REQUEST

Current Zoning: MUDD-O (mixed use development, optional)
Proposed Zoning: MUDD-O SPA (mixed use development, optional, site plan amendment)

SUMMARY OF PETITION

The petition proposes an amendment to the previously approved rezoning petition to allow the reuse of an existing building and additional redevelopment on the site. The proposal would modify the conditions related to signage and additions to the existing building that remains.

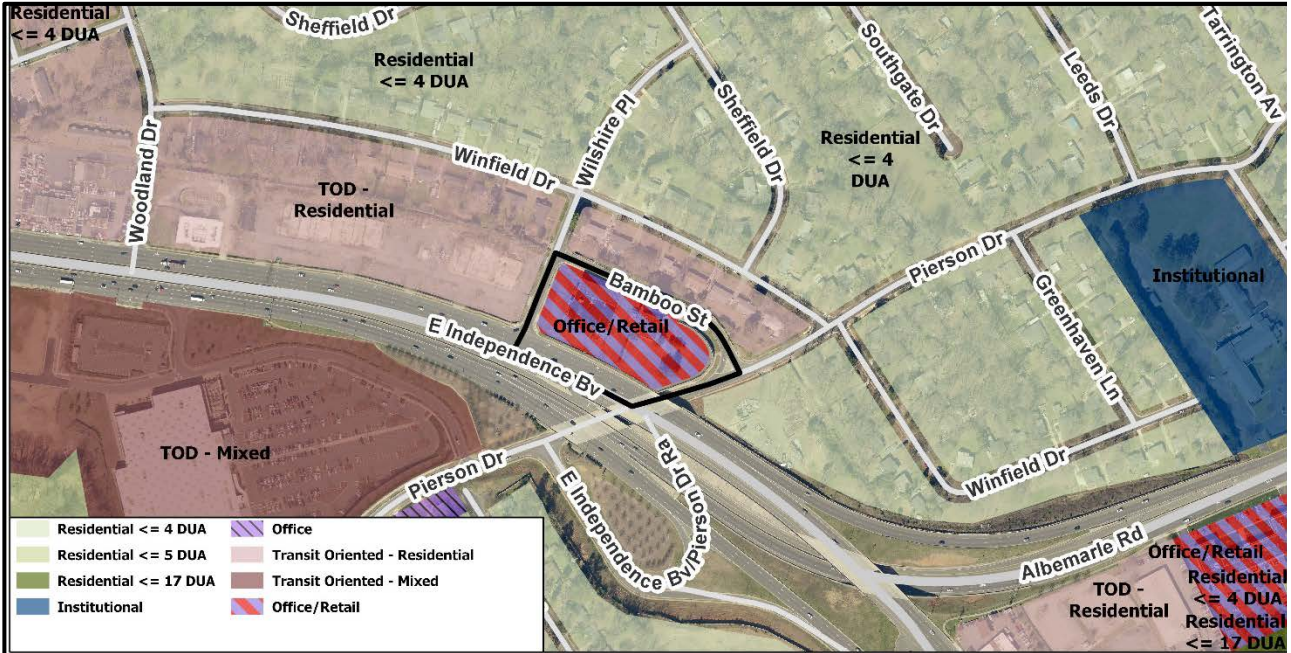
3. Add a conditional note to specifying replacement of the existing CATS bus stop pad as indicated by the site plan.
 4. Revise the site plan (RZ-2) to show the existing stairs that are shown in the sidewalk area along Bamboo Street to be removed from the right-of-way. In addition, please propose to install a safety rail or a gated system to prevent pedestrians, within in the right-of-way, from falling into the drop-off.

5. Revise the site plan (Sht. RZ-2) to clarify whether the existing driveways on Bamboo Street will remain or be replaced. Sheet RZ-2 calls for the existing driveways to remain, but the site plan shows the existing Commercial Type II Driveway to be replaced with a Type II Modified Driveway at the access west of the existing Ervin building.

6. Revise the site plan (RZ-2) to include proposed and existing sidewalk labels and dimensions.
-
